**MODIFICATION REQUEST:
Vincentia District Centre – Corner Naval
College Road and The Wool Road
MP 06_0025 MOD 4**

Modification Request

Modifications to the building footprint, finished floor level, roofline, internal mall widths, materials and finishes, loading dock and car parking.

Director-General's
Environmental Assessment Report
Section 75W of the
Environmental Planning and Assessment Act 1979

Figure 2: Street Cross Section of Existing and Proposed Setback to Moona Creek Road

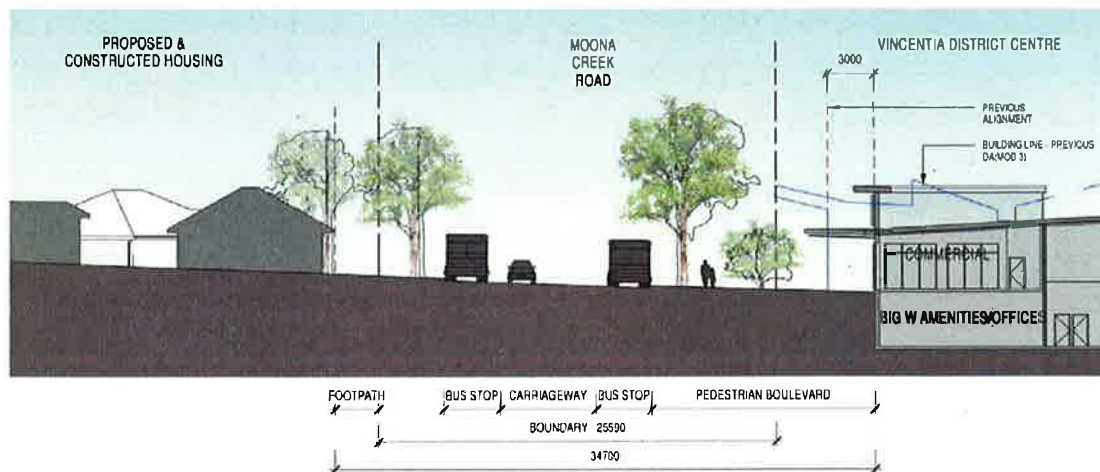
The proposal includes increasing the setback of the external walls of the specialty tenancies abutting the Wetlands on the north eastern façade by 5m. It is also proposed to increase the setback along Moona Creek Road by 3m.

As the above street cross section shows, the proposed additional 3m setback to Moona Creek Road appears minor in comparison to the overall width of the street. The proposed modification will not impact the original design intent of the concept of the 'gateway building' as the scale and façade treatments are being retained.
